Subject: Collin County Healthcare Facility, Parking Garage, and Medical Examiners
PCO No. 142; RFI #462 PG Gaps in Concrete

Issue No. 142 - RFI #462 PG Gaps in Concrete

RFI #462: PG - Gaps in Concrete

PG-S2.03

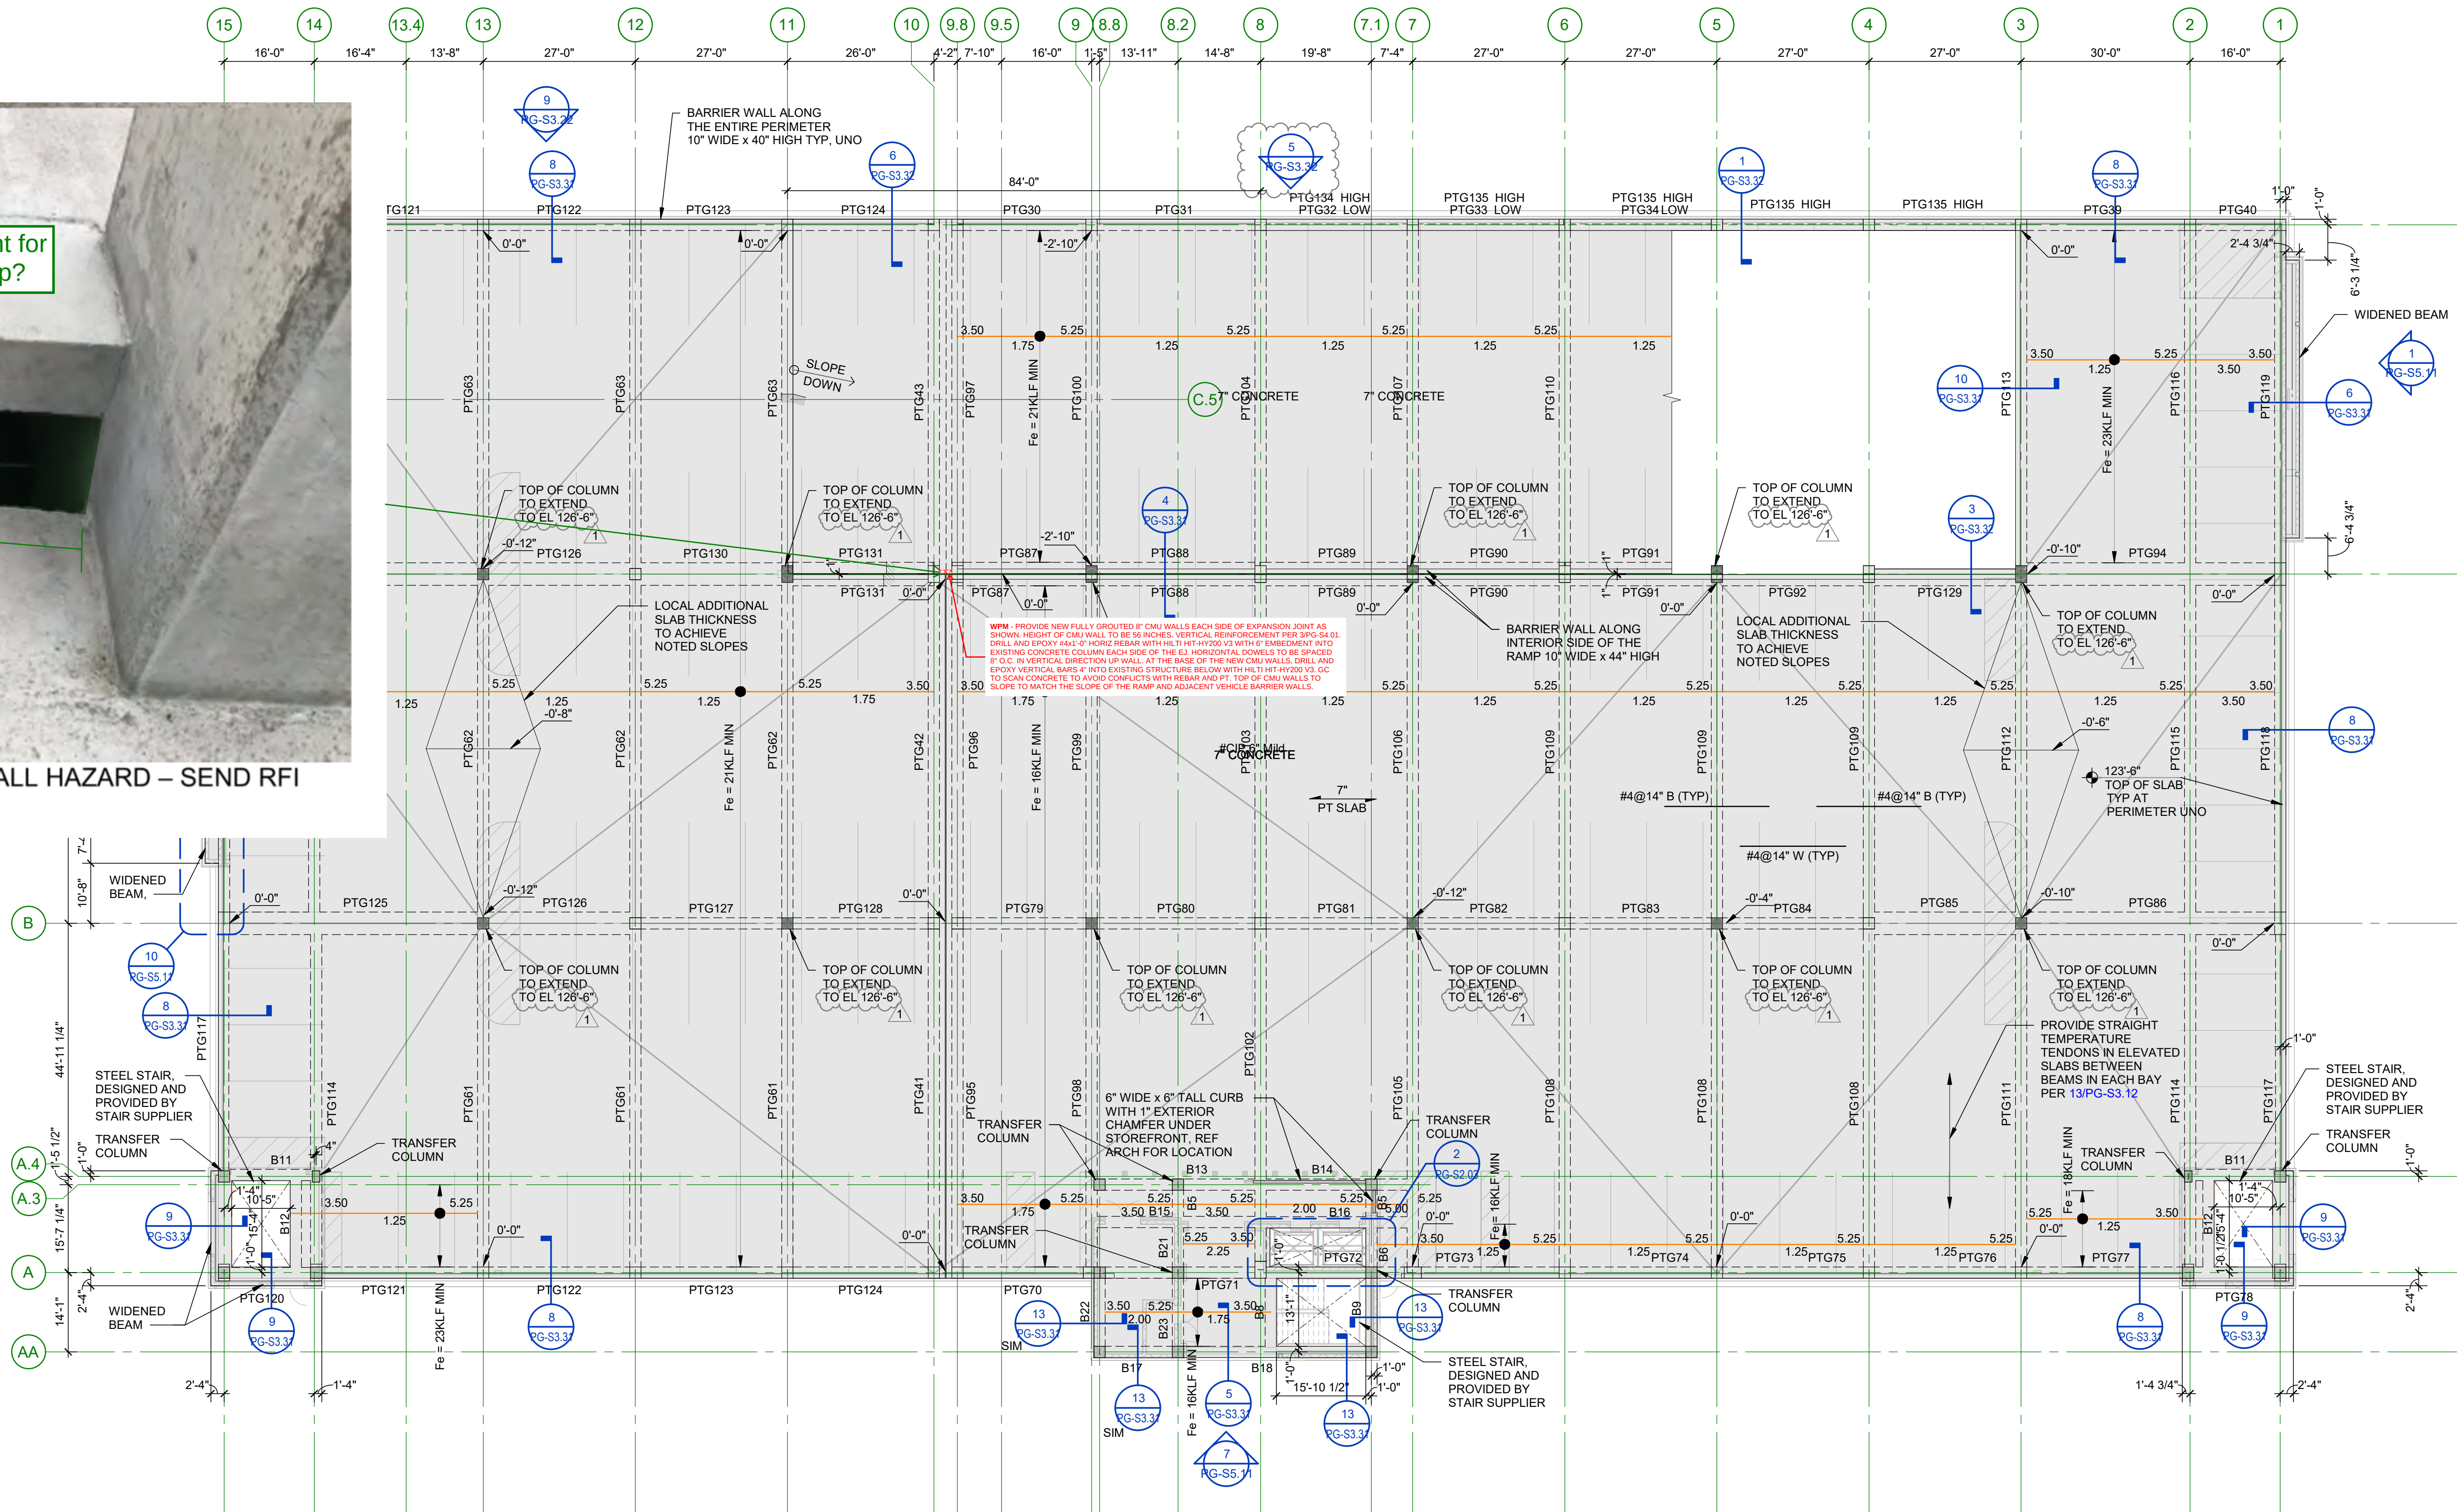
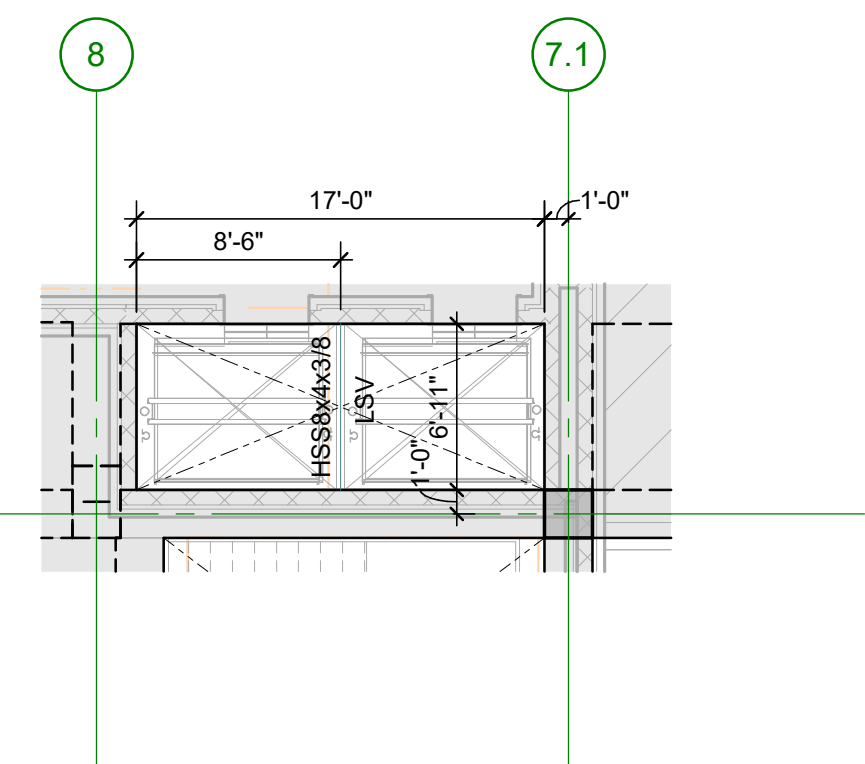
In the Parking Garage, there are two areas with gaps that are a potential cause for concern. On the ramp between L2 and L1, there is a gap in the concrete that measures 9' in height and 27" in width. What is the intent for closing this gap, if any is needed?

OPENING TOO LARGE AND CREATES A FALL HAZARD – SEND RFI FOR CORRECTIVE ACTIONS

SEE WPM RESPONSE ATTACHED FOR THE GAP IN CONCRETE QUESTION ON THE RAMP BETWEEN L2 AND L1. WPM DEFERS TO ARCH FOR THE RESPONSE TO THE LOUVER QUESTION.

1 FOUNDATION LOWER LEVEL PLAN

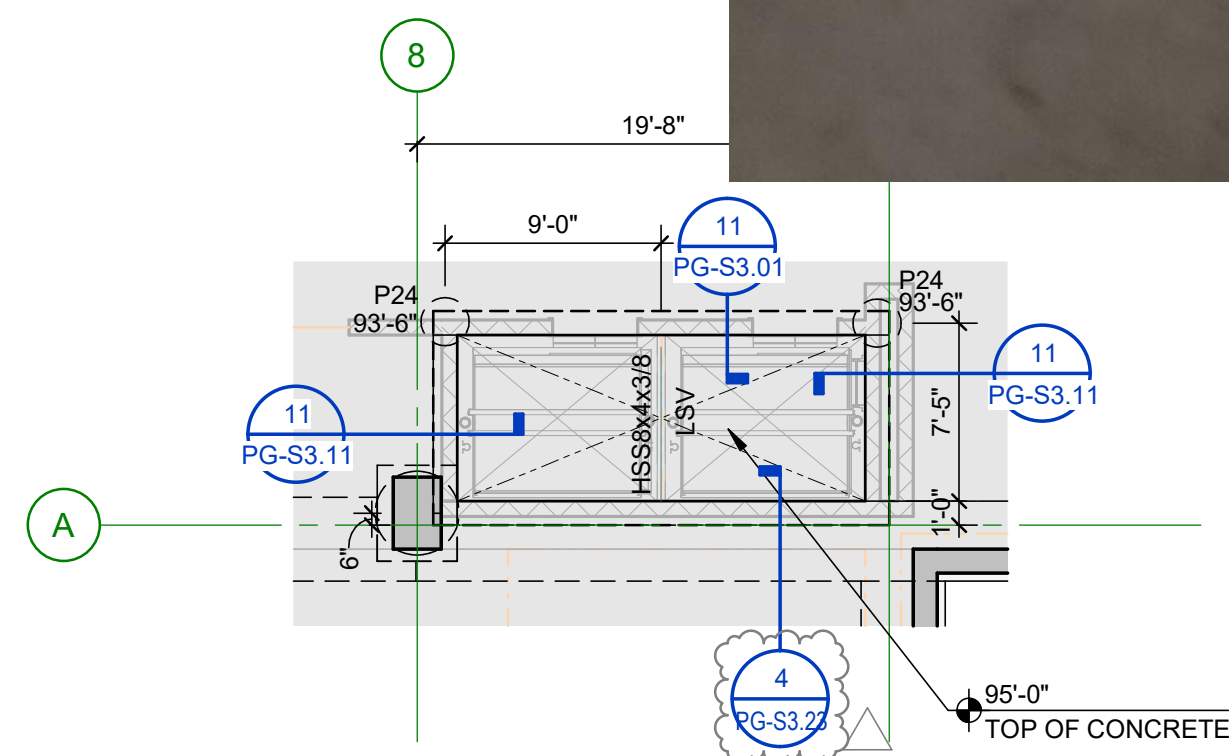
Additionally, on the lower level, there is a gap between a louver and the angled beam that measures approximately 15" high at the tallest point by 18' long. What is the intent for closing this gap, if any?

What is the intent for filling this gap on the lower level?

PGAL did not raise the gap between the louver and the bottom of ramp as a deficiency. Was this concern raised by the owner? If this is still a concern, PGAL would recommend closing the gap with a partition comprised of 3 5/8" studs and 5/8" painted gyp. board on either side braced back to underside of ramp as needed for stiffness.
